Product Bulletin:

Subject: Front Upper Rail Change

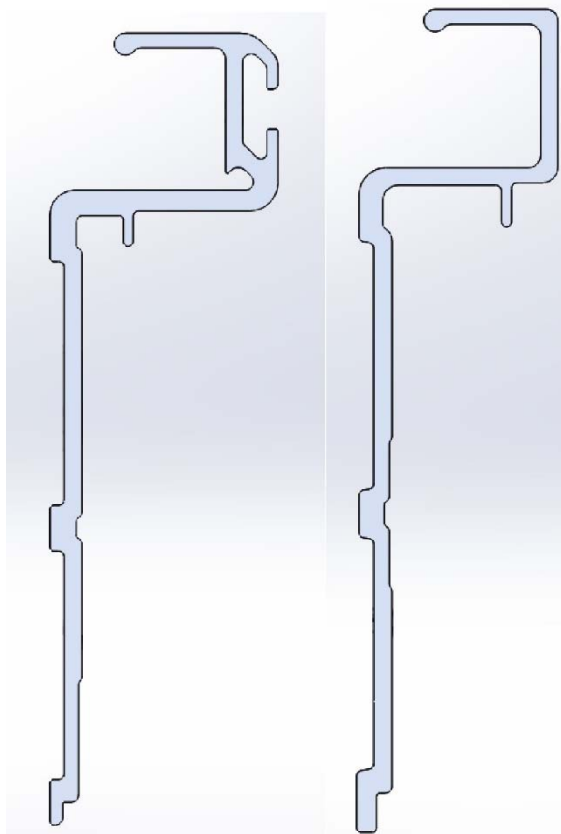
Stoughton Trailers has redesigned the upper front rail for dry van trailers. This running change will be implemented over the next few months, beginning next week in the Stoughton plant. The old profile will only be used if the specified trailer requires roof liner. This redesigned rail will help further prevent water intrusion as well as improve the fit-up to the front corners.
